APPROVED
 Limited building only review
 Permit holder responsible for
 full compliance with the code

Build new porch on existing deck

Existing Deck / Stairs

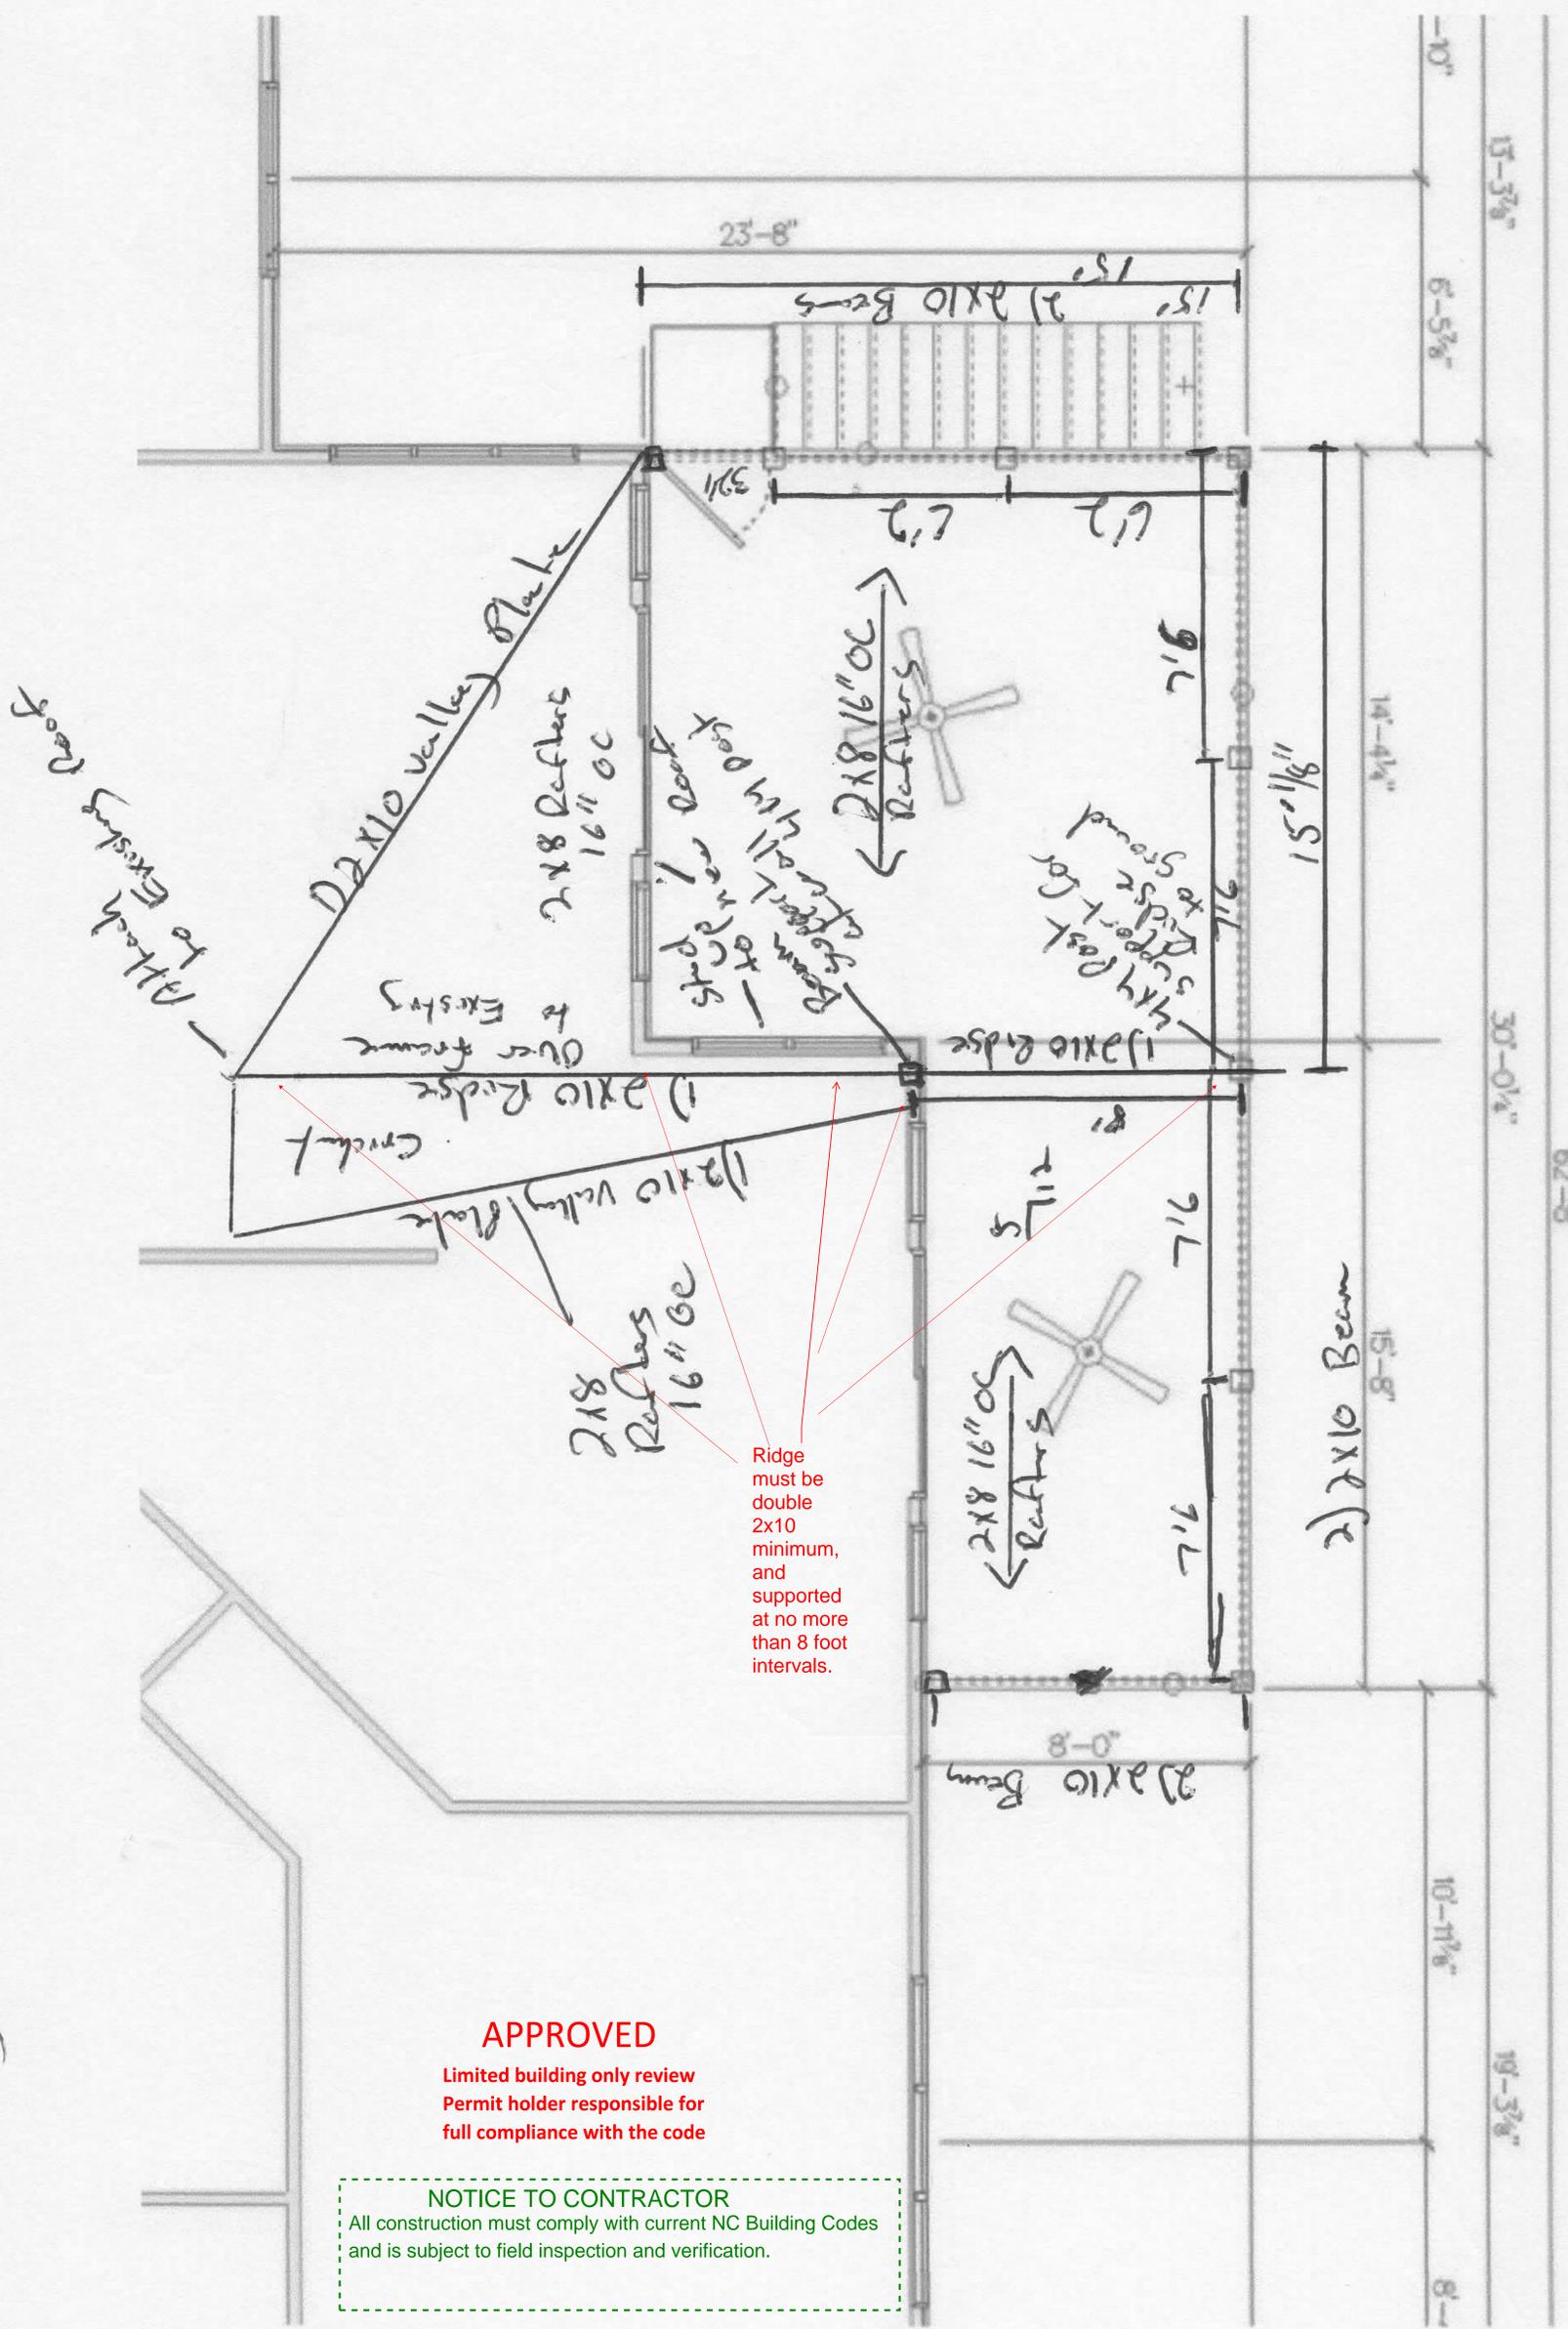
Ceiling rafters 2x6 to span no more than 4' in upper 3rd of ceiling 16" OC

Deck is existing Double 2x10 Band all 3 sides
 2x10 FT 160c on large section 2x8 FT 16" OC on small section
 Deck supports are CAG Post at same locations as 4x4 Post shown on Plans

Existing Deck has Double 2x10 Band on all 3 sides
